ADDENDUM #2

FROM : ARCHITECTNICA
555 W. BENJAMIN HOLT DRIVE
SUITE 423
STOCKTON, CA 95207
(209) 952-5850 FAX (209) 952-2442

PROJECT: Bridge Classroom Portable at Beckman ES
Lodi Unified School District

DATE : August 25, 2026

UNIT J RESTROOM
INTERIOR
ELEVATIONS -
PROPOSED

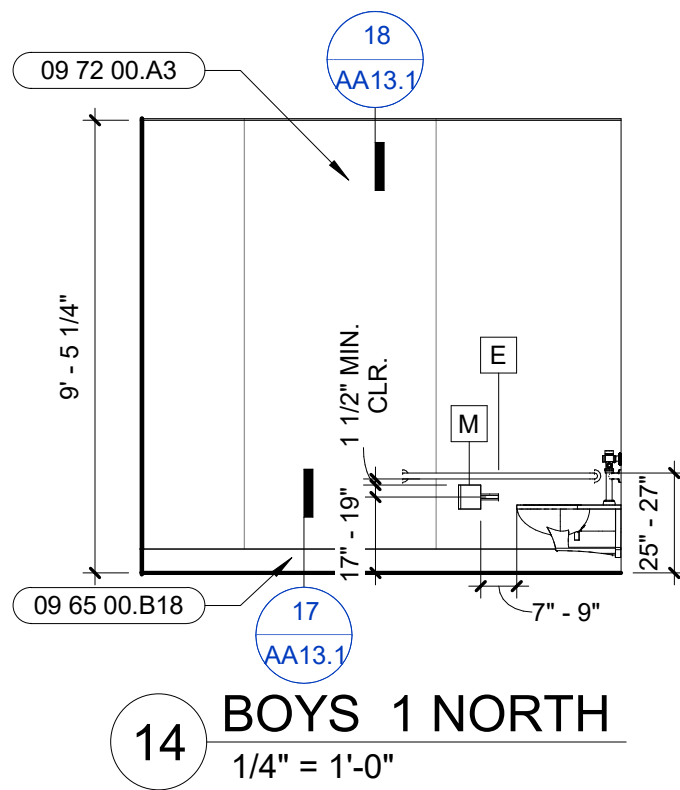
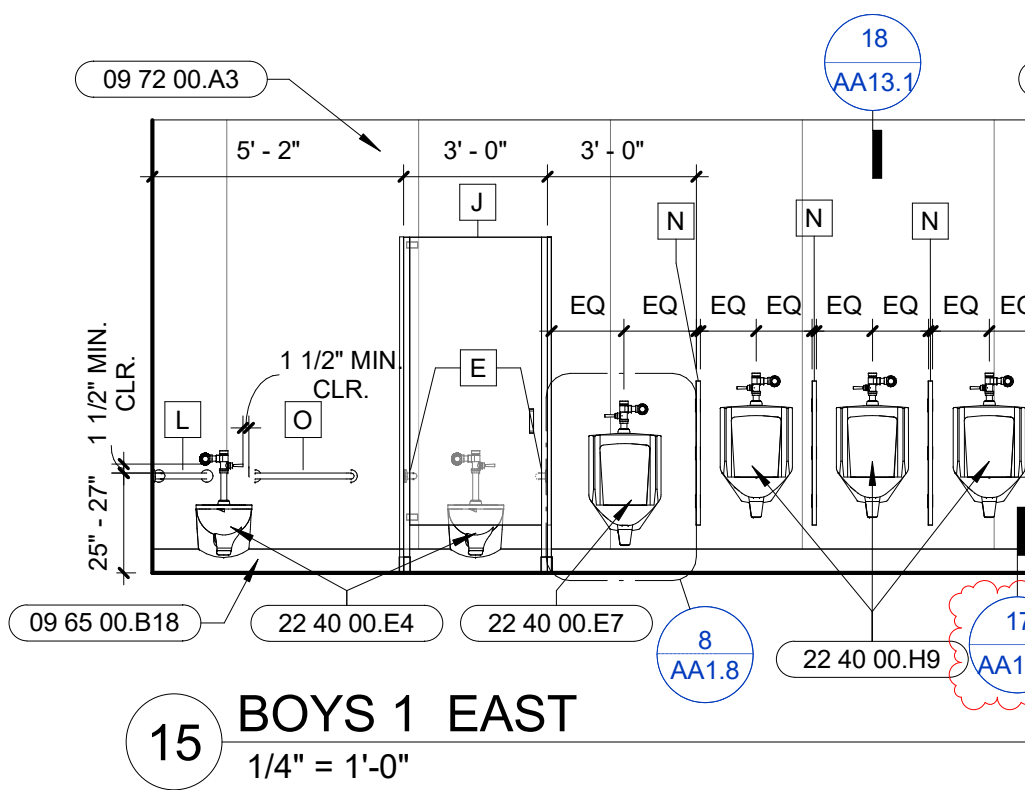
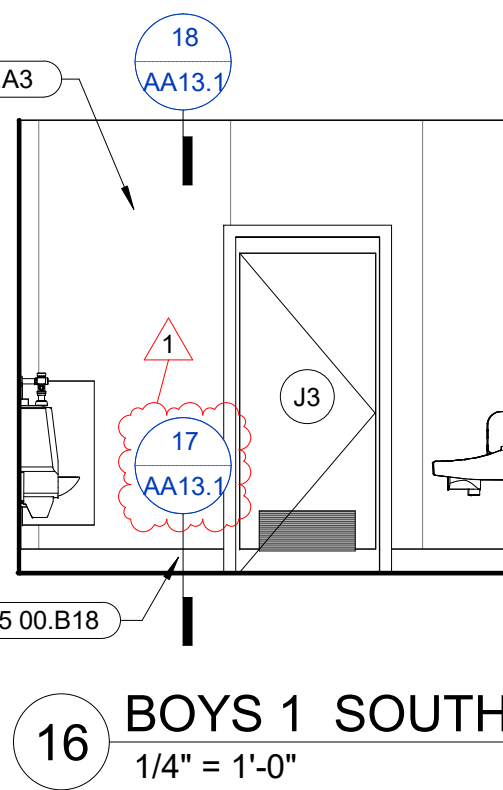
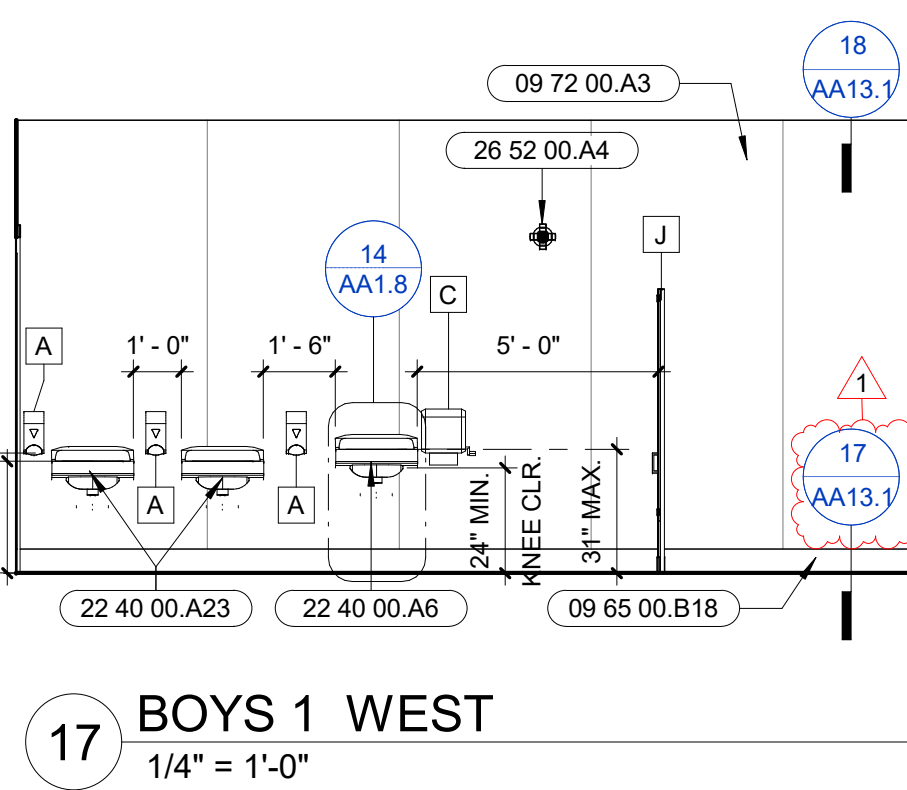
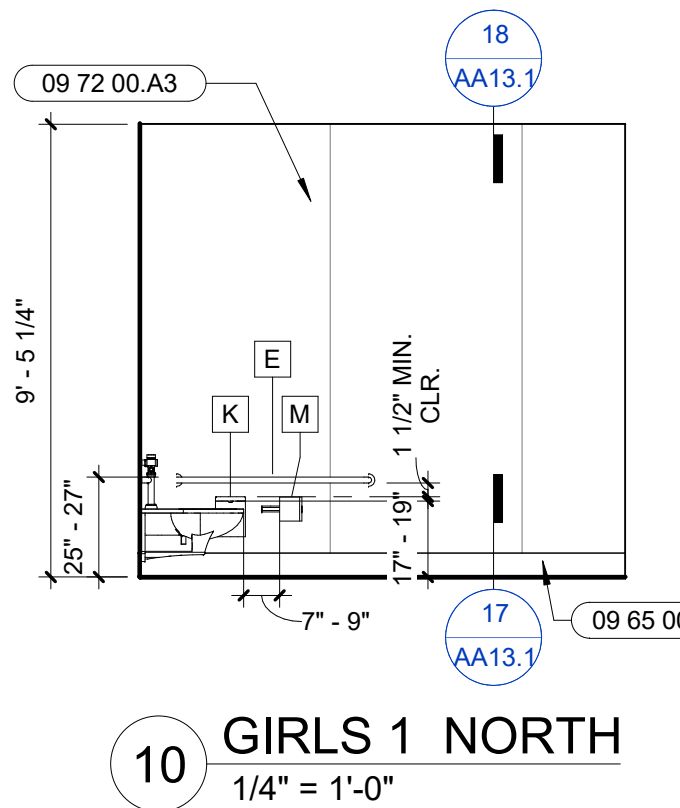
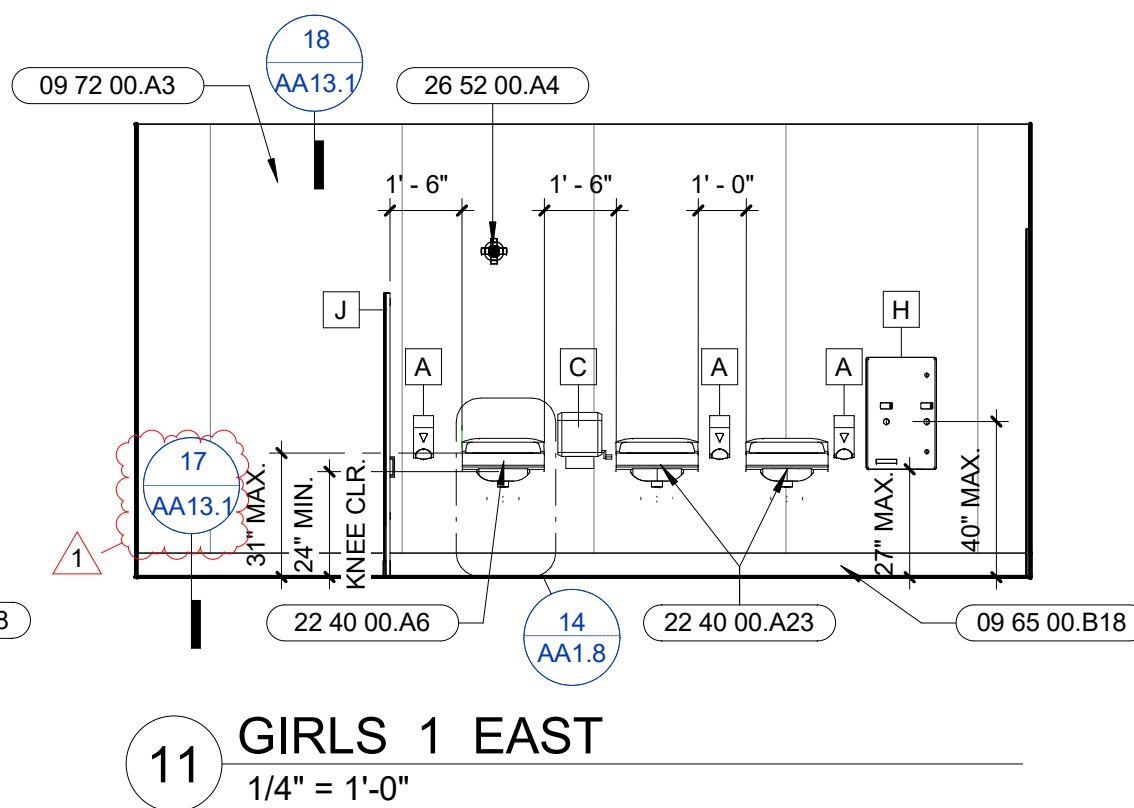
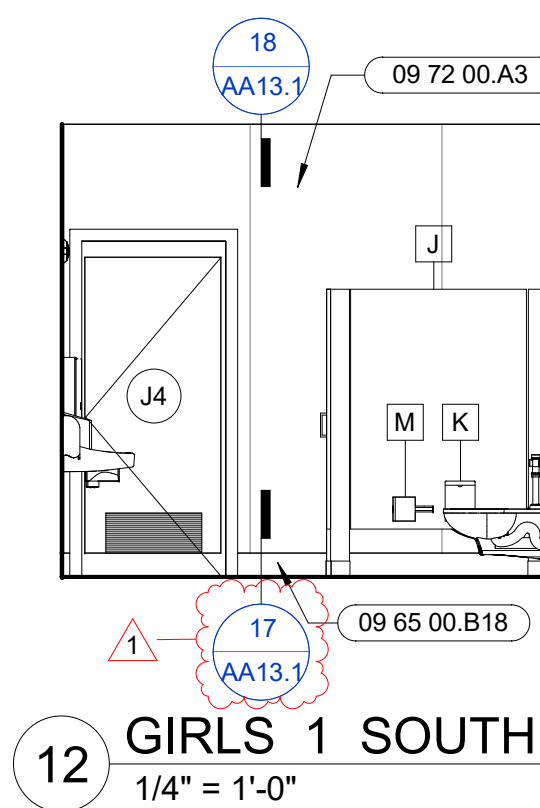
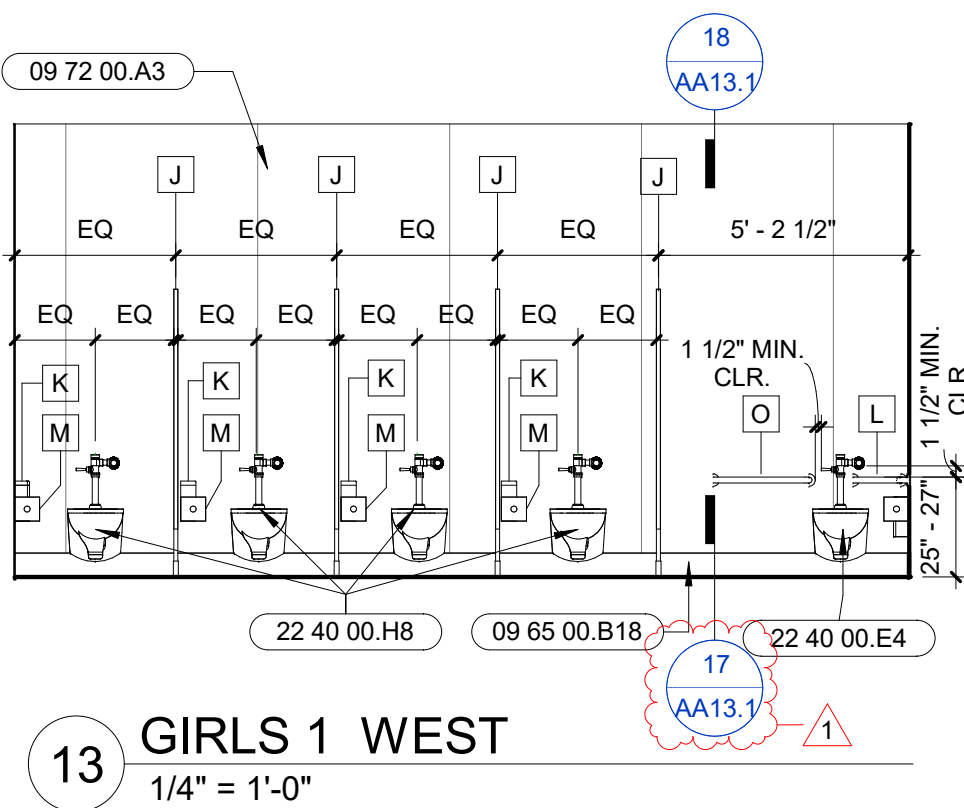
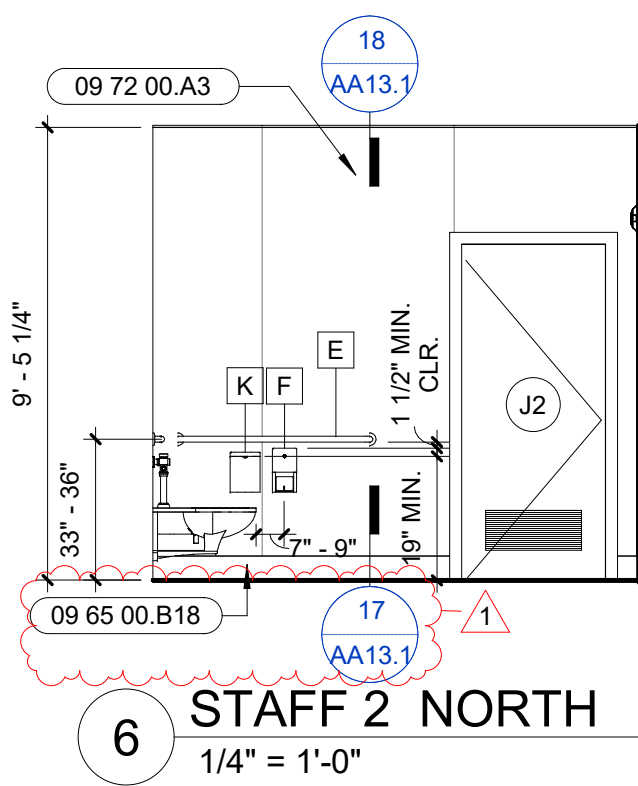
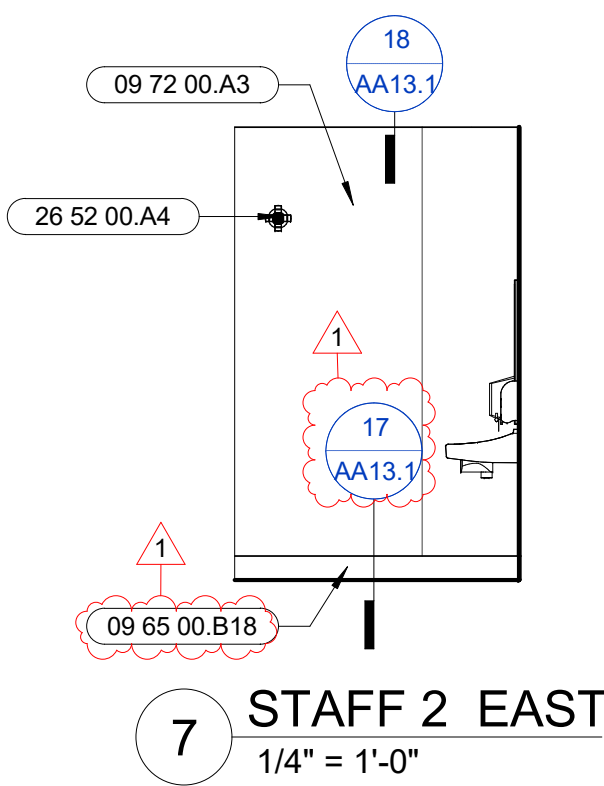
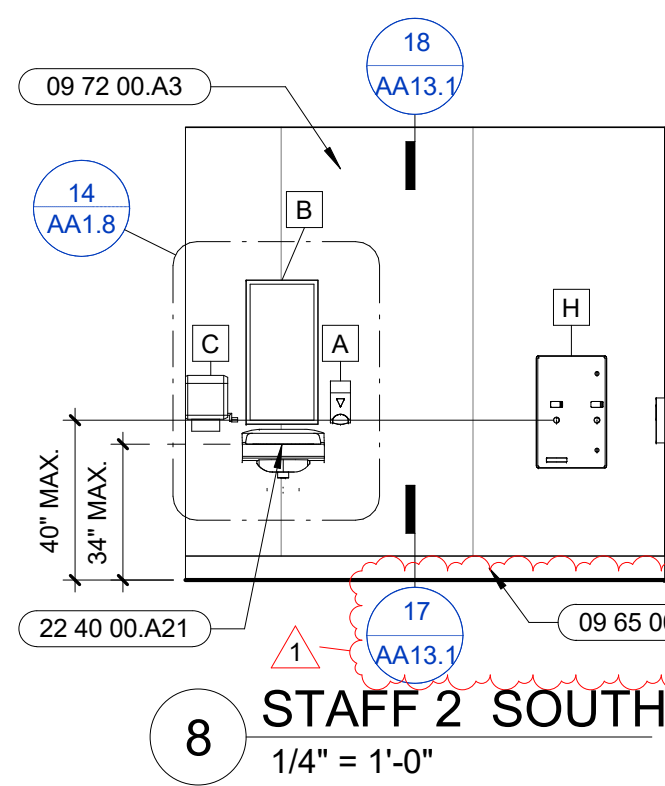
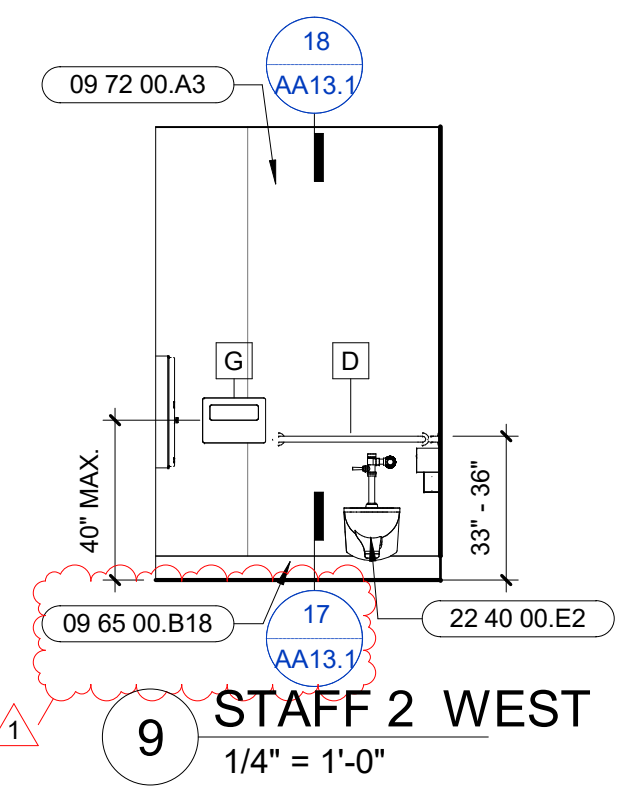
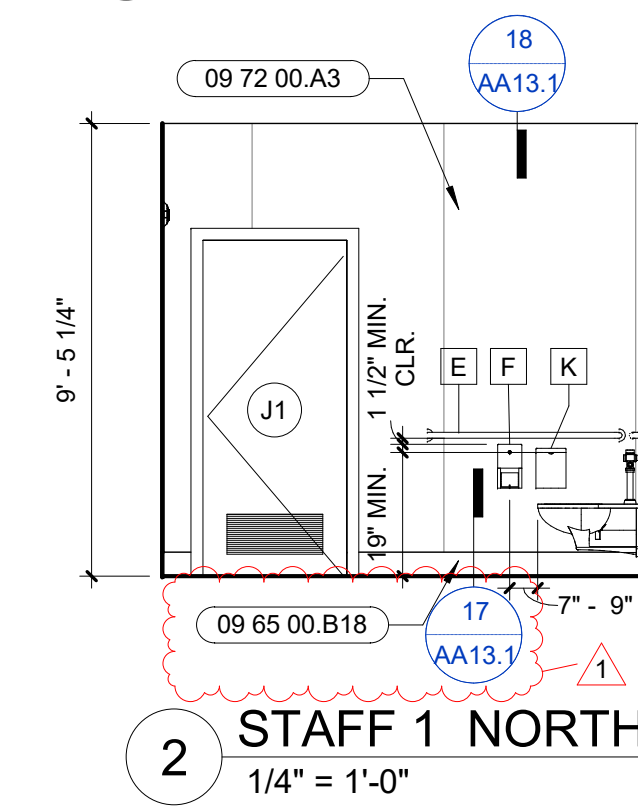
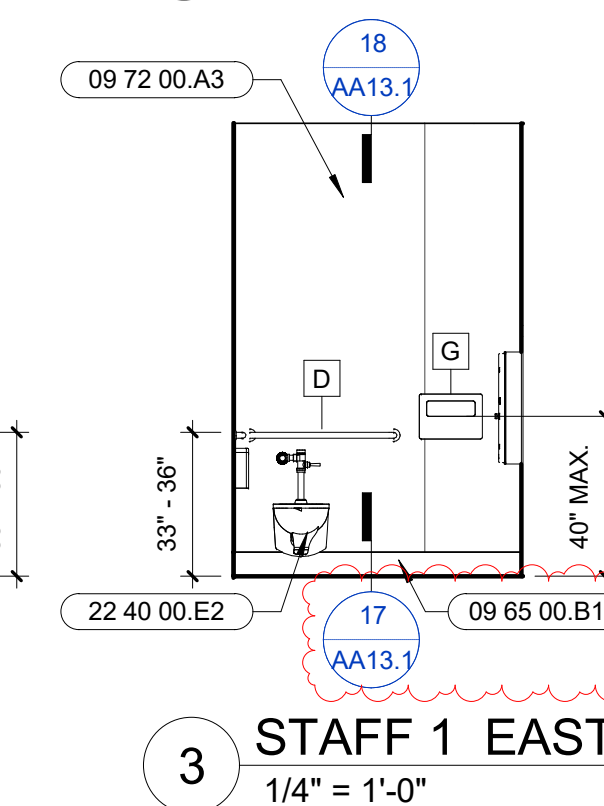
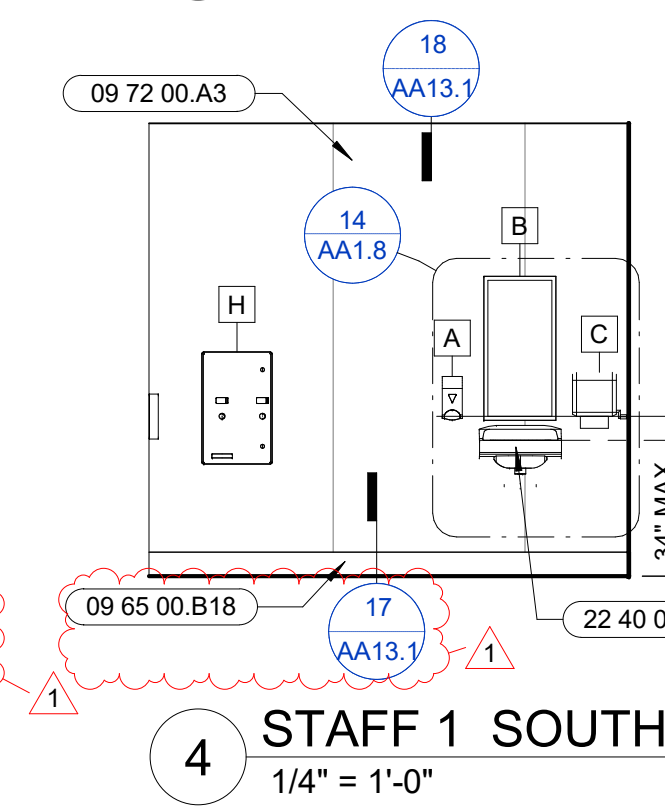
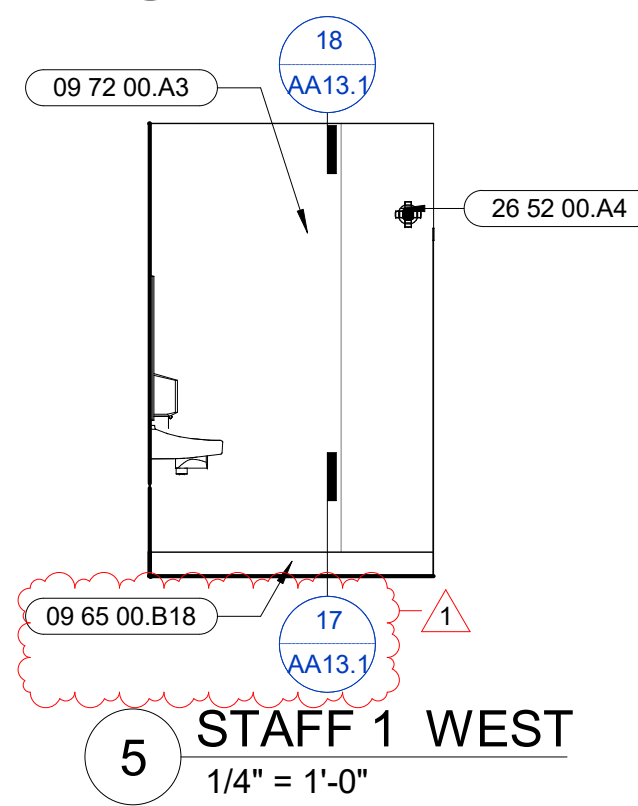
- Per keynote spec 09 65 00 A13 and B22 on page AA2.2, there is to be epoxy base and precast cove base. Is the bathroom floor also epoxy and if so, please provide the correct specifications for the items listed.

A: There will be no epoxy flooring or epoxy base in this project. The staff restrooms and the student restrooms will be sheet vinyl flooring with 6" high sheet vinyl coved base. Drawings have been updated to reflect this change.

FINISH SCHEDULE						
ROOM NO.	ROOM NAME	CEILING FINISH	FLOORING	BASE	WALL FINISH	COMMENTS
130 (UNIT J)	STAFF 1	GYP BD, PAINTED	SHEET VINYL	6" HIGH SHEET VINYL COVE BASE	FRP (FULL HEIGHT)	
131 (UNIT J)	STAFF 2	GYP BD, PAINTED	SHEET VINYL	6" HIGH SHEET VINYL COVE BASE	FRP (FULL HEIGHT)	
132 (UNIT J)	BOY'S RR	GYP BD, PAINTED	SHEET VINYL	6" HIGH SHEET VINYL COVE BASE	FRP (FULL HEIGHT)	
133 (UNIT J)	GIRL'S RR	GYP BD, PAINTED	SHEET VINYL	6" HIGH SHEET VINYL COVE BASE	FRP (FULL HEIGHT)

Typical Classroom Data Jack Layout
(12 Data Cables per Room)

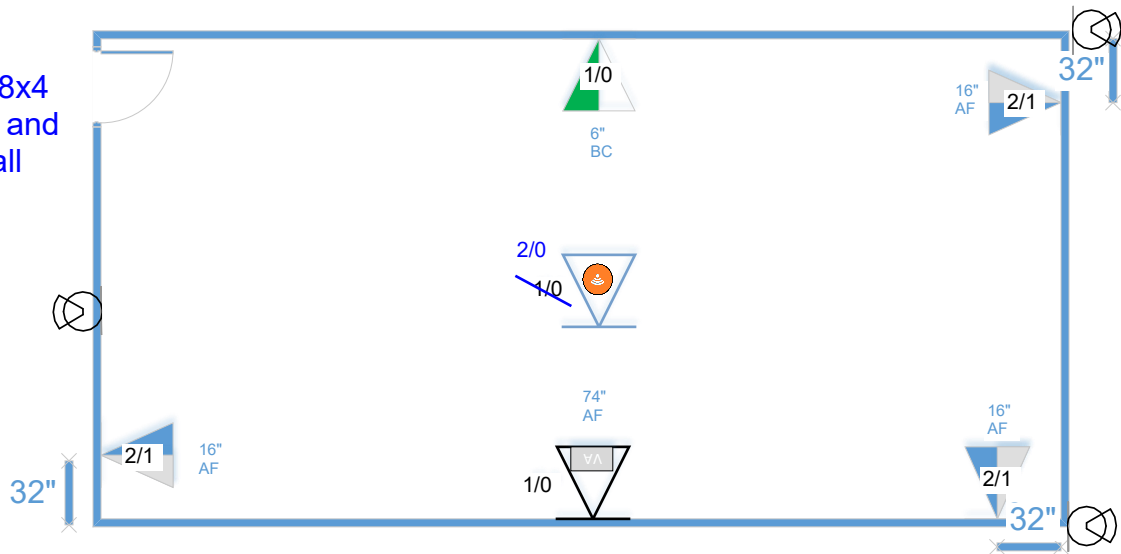
ITEM 6 Low Voltage / Data Clarification

At Portable Classroom Building P, Low Voltage / Data Drops are to be installed in accordance with 1-Es2.1 in Addendum 1 and the District standard portable classroom template (exhibit attached to this addendum for clarity). There are to be 12 interior data drops +3 drops for 3 cameras (1 drop per camera) +1 Spare at Wifi Data = Total 16 data drops. The awarded contractor is to provide wiring and 8x8x43R NEMA rated boxes for cameras. District will provide and install camera devices.

Refer to Addendum 1 Signal Plan on 1-ES2.1 for Drop locations and Information.

12 interior data drops +3 drops for 3 cameras (1 drop per camera) +1 Spare at Wifi Data = Total 16 data drops.

Contractor to provide wiring and 8x8x4 3R NEMA rated boxes for cameras and Horns. District will provide and install cameras.
